New Curtain Style Airbags

Vehicle Type: **911 (991-II) Coupe / 718 Cayman (982)**

Concern: **Production change**

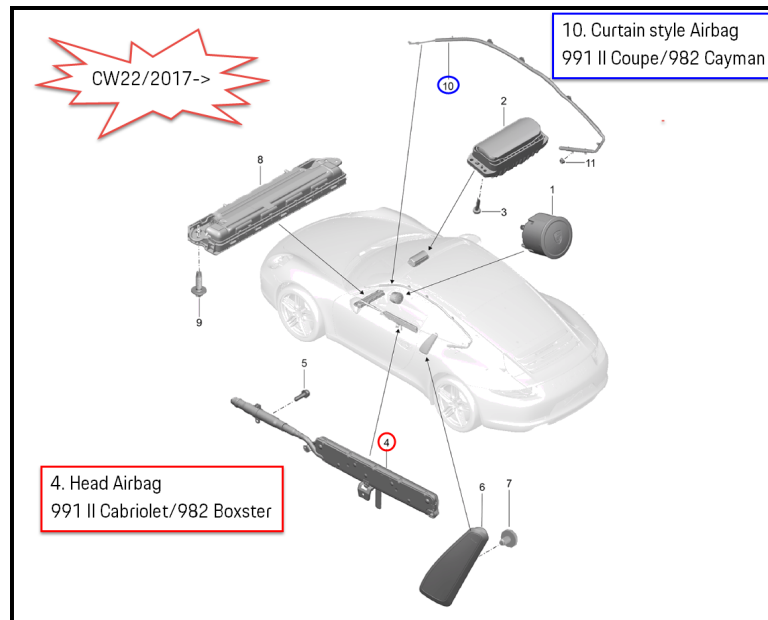
Information: There was a production change to the airbag system in sports cars (991 II/982) starting in CW22/2017. All Coupe versions now have a curtain style head airbag, as opposed to the head airbag previously (still in Cabriolet versions) found in the doors.

The new location can be easily ascertained by the location of the "Airbag" script as shown in the images on the next page.
